SERVICE LETTER

THRUSTER ASSEMBLY WASHER MODIFICATION

MODELS AFFECTED: All MD900 helicopters.

9L67-002

Figure 1. Location of Thruster Assembly Washer Modification

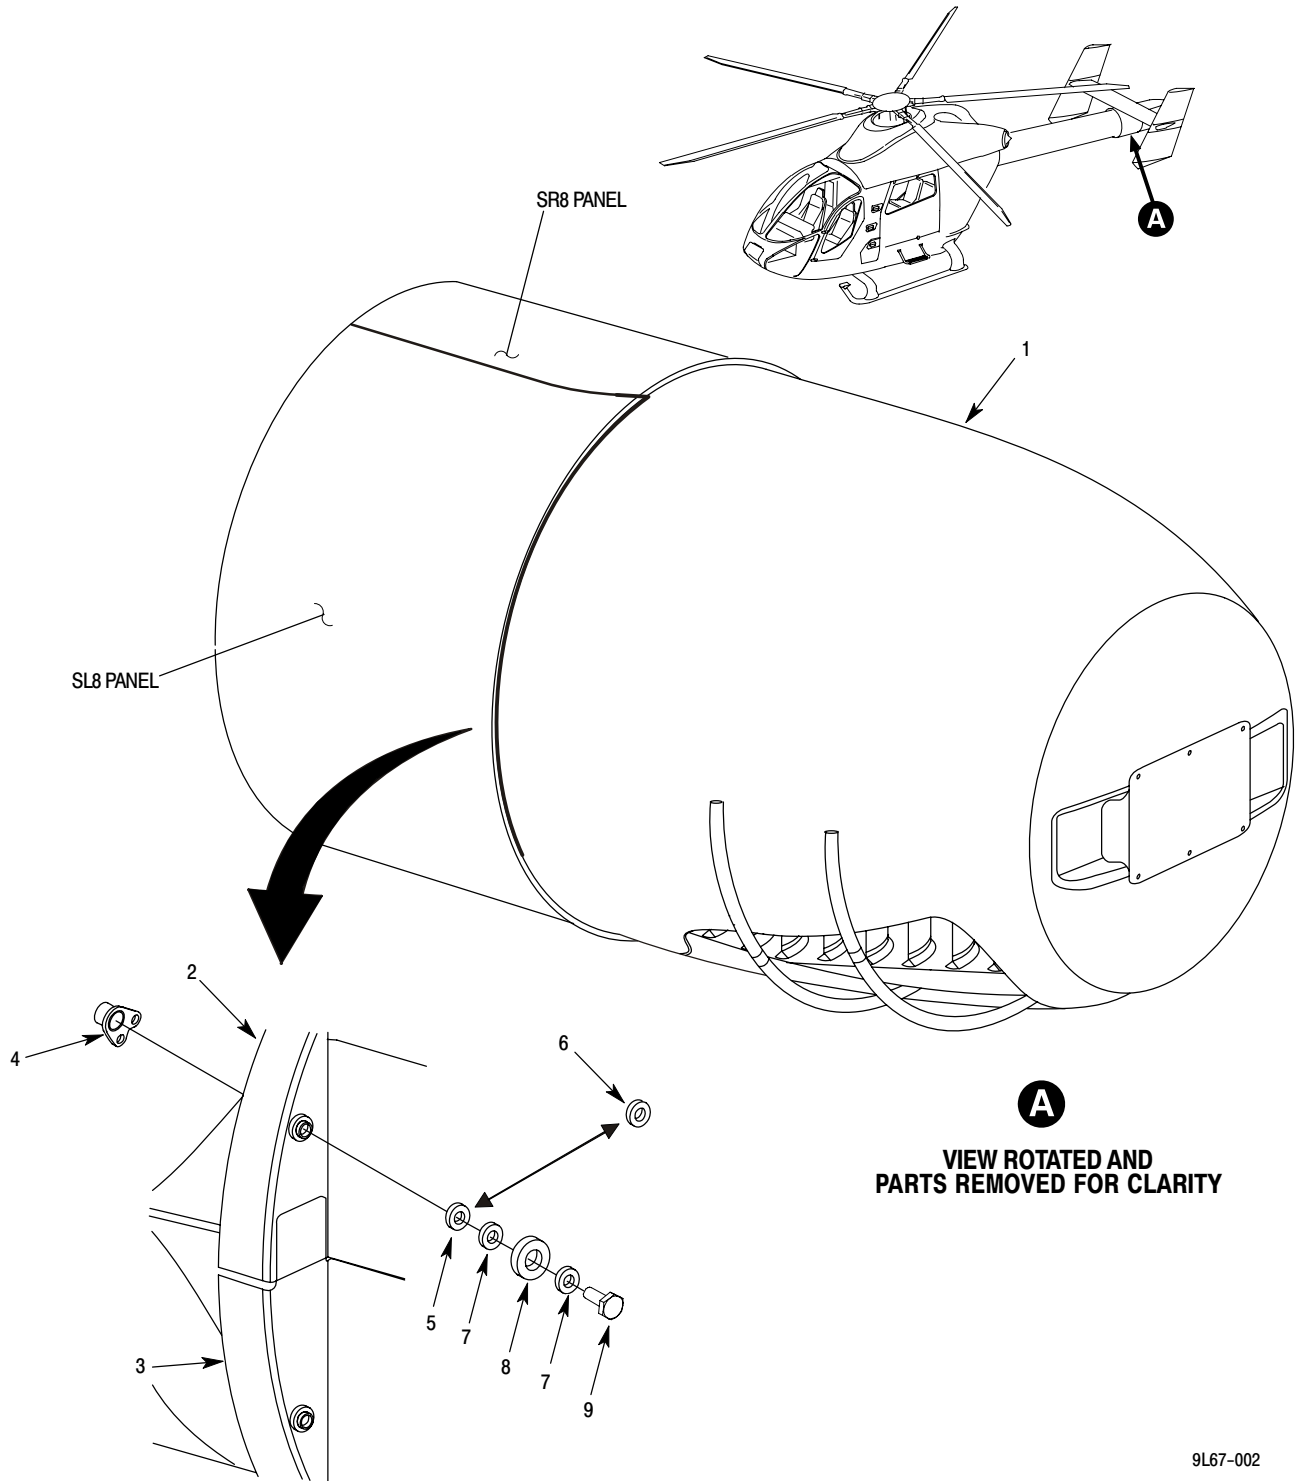
This service letter is issued to tell owners and operators that the control bearing (ref. Figure 1) for the rotating cone assembly may not move freely because the attaching bolts have been over-torqued during installation. Torque more than **30 in-lb (3.4 Nm)** can cause the nylon flat washers to extrude and cause an interference with bearing rotation. At the next bearing inspection/replacement interval, MDHI recommends the removal of flat nylon washers, PN NAS1515H3L (5), and their replacement with corrosion-resistant steel (CRES) flat washers, PN NAS1149C0363R (6). The CRES flat washers are thicker and provide increased clearance from the face of the thruster bulkhead.

At the next access to, or during scheduled maintenance to the control bearings, replace flat nylon washers with CRES flat washers. Install control bearings with new washer in the thruster assembly. Correctly torque bolts **15 to 20 in-lb (1.7 to 2.3 Nm)** plus run-on torque to get the correct locking torque on the nutplate. If it is necessary to remove remaining axial play of the stack-up, torque bolts to **24 in-lb (2.7 Nm)** maximum.
